To: **City of Pitt Meadows** Date: **January 12, 2020**
Attention: **Allison Dominelli | Development Services Technician** Project No.: **32334**
Cc:
Reference: **GEBP (Phase 3 & Phase 4) Landscape Review**
From: **Jose Gonzalez, MBCSLA**

Design Review		
Reviewing Firm: ISL	Reviewer: Jose Gonzalez, Landscape Architect, MBCSLA	Date: 2020-01-08
Project Name: Golden Ears Business Park (GEBP) Phase 3 & Phase 4, Pitt Meadows, BC		Stage: Issued for DP review
Review Discipline: Landscape Architecture		Revision: 0

Ld-1 Typical Tree Planting

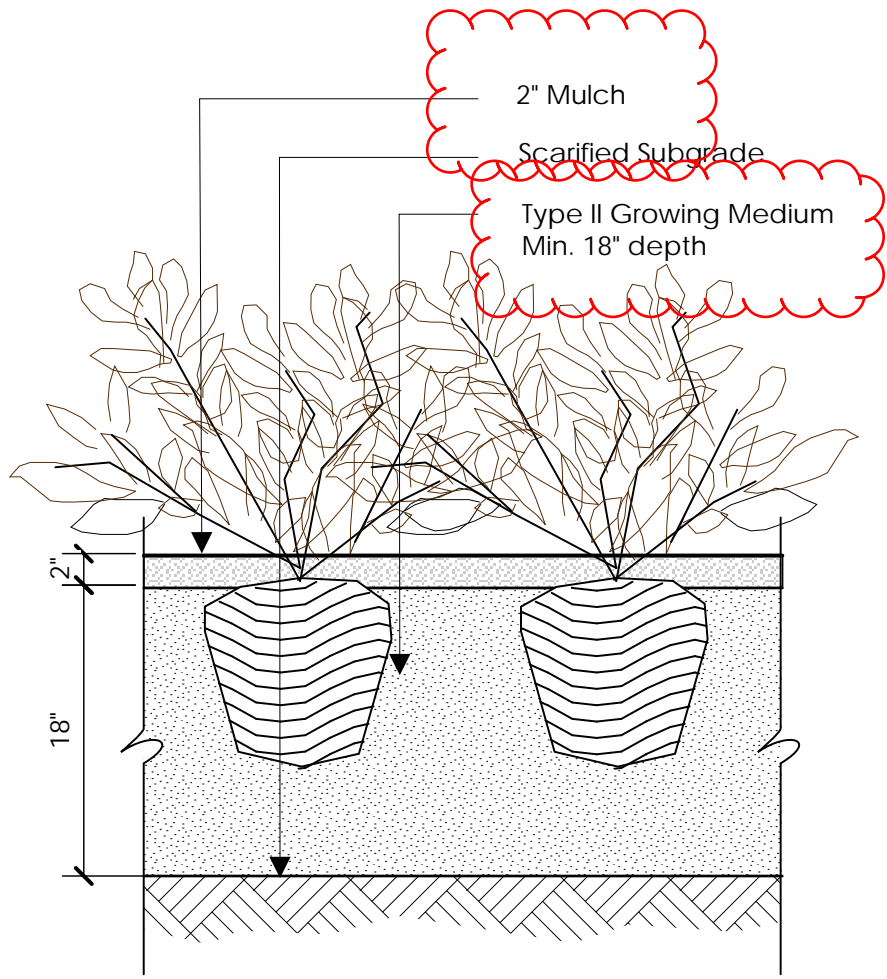
37	Ld-1 / L-16	increase Mulch over from 50mm to 75mm on trees and shrubs.	
38	Ld-1 / L-16	Remove reference to 'Screened growing medium". Use Growing Medium specification as per Canadian Landscape Standards instead (e.g. Growing Medium Type 2P)	
39	Ld-4 / L-16	Hydroseed on 6" of growing medium, not 8"	
40	Ld-6 / L-16	Remove reference to "play area"	
41	Ld-7 / L-16	Increase asphalt depth to 3" if vehicular access is foreseen for maintenance.

Ld-4 Hydroseeded on grade

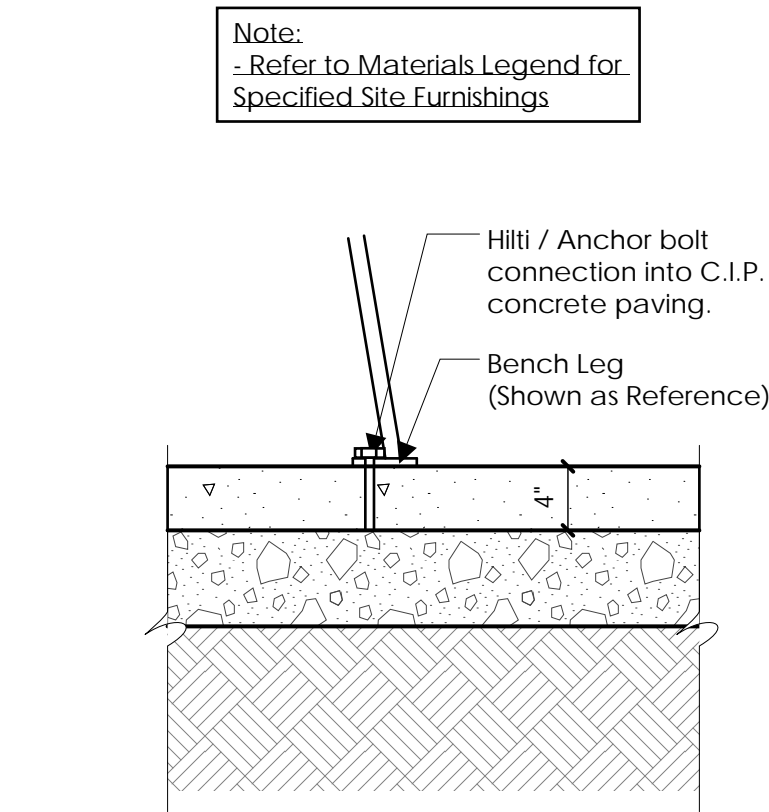
35	Ld-4 / L-16	Hydroseed on 6" of growing medium, not 8"	
36	Ld-6 / L-16	Remove reference to "play area"	
37	Ld-7 / L-16	Increase asphalt depth to 3" if vehicular access is foreseen for maintenance.	
38	Ld-3 (Ld-9) / L-16	Provide specifically engineered biofiltration media along bio-swale (ECOMedia by Veratec or similar.)	
39	Ld-3 (Ld-9) / L-16	Ensure Bioswale detail is coordinated with Civil
